Item ID: D206-667-147TRN

Item Name: Crosstube Assembly, Mid Fwd

<b>DART AEROSPACE LTD</b>		<b>Work Order:</b> 88903
<b>Description:</b> Crosstube Assembly, Mid Fwd		<b>Part Number:</b> D206-667-147TRN
<b>Inspection Dwg:</b> D206-667-147 Rev: A		<b>Page 1 of 2</b>

DRAWING NO. D206-667-147	TITLE CROSSTUBE ASS'Y (206L MID FWD)	REV. A	<b>DART AEROSPACE LTD ENGINEERING ORDER</b>		D.E.O. NO. D206-667-147-A-1	SHEET NO. SHEET 1 OF 1	SCALE NTS
DRAWN 92	CHECKED ADS	MFG. APPR. [Signature]	APPROVED [Signature]		DE APPR. [Signature]		
DATE 11.07.15	DATE 11.07.20	DATE 11.07.21	DATE 11.07.21		DATE 11.07.21

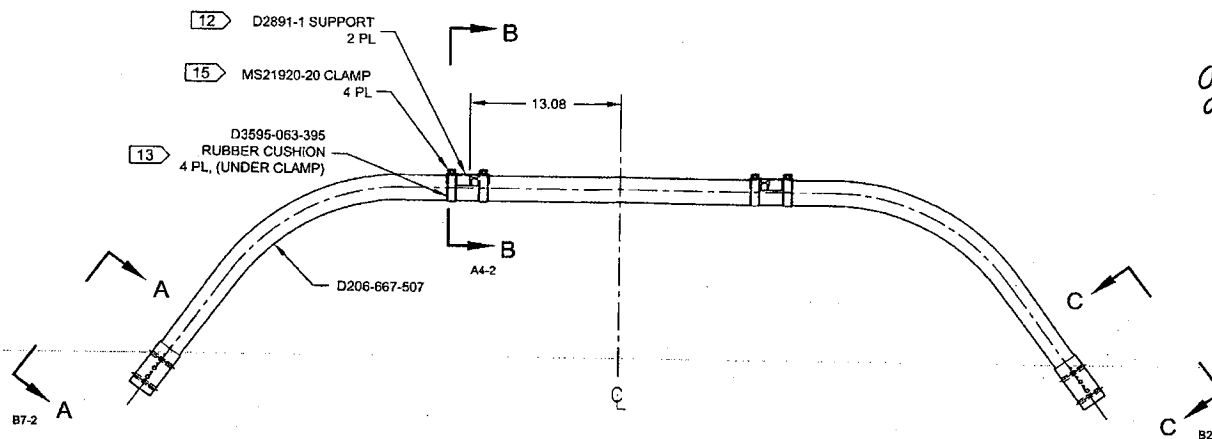
**PURPOSE:**  
REPLACE MAGNOBOND WITH PROSEAL.

IS:

Item	Qty -147	Part Number	Description
9	A/R	PROSEAL 890 B-2	SEALANT, AMS-S-8802 CLASS B-2

WAS:

9	A/R	MAGNOBOND 6398	ROCKWELL SPECIFICATION RBO-120-023 ADHESIVE (TEXTRON/BELL SPEC. 299-947-100, TYPE II, CLASS 2 ADHESIVE)
---	-----	----------------	---

NOTE 12 & 15, SHEET 1 IS AMENDED AS FOLLOWS:

WAS:

- 12) INSTALL D2891-1 SUPPORT USING 0.03" TO 0.06" THICK LAYER OF MAGNOBOND 6398 PER QSI 015. LET CURE FOR 12 HOURS AFTER INSTALLATION AND PRIOR TO PACKAGING.
- 15) TORQUE CLAMPS 80 TO 100 IN-LB. ENSURE AT LEAST 1.5 THREADS SHOWING IN SAFETY AND THAT NUT HAS NOT BOTTOMED-OUT AFTER TORQUING.

IS:

- 12) TO INSTALL D2891-1 SUPPORT: ABRASE MATING SURFACE OF SUPPORT AND CROSSTUBE WITH 180-GRIT SANDPAPER AND REMOVE RESIDUE WITH MEK (OR EQUIVALENT). APPLY A 0.04" TO 0.07" THICK LAYER OF PROSEAL 890 CLASS B-2 (OR AMS-S-8802 CLASS B-2) SEALANT TO MATING SURFACE OF SUPPORT.
- 15) TORQUE CLAMPS 80 TO 100 IN-LB. ENSURE AT LEAST 1.5 THREADS SHOWING IN SAFETY AND THAT NUT HAS NOT BOTTOMED-OUT AFTER TORQUING. **PRIOR TO PACKAGING, RE-CHECK TORQUE ON CLAMPS AFTER PROSEAL 890 SEALANT HAS CURED FOR 72 HOURS.**
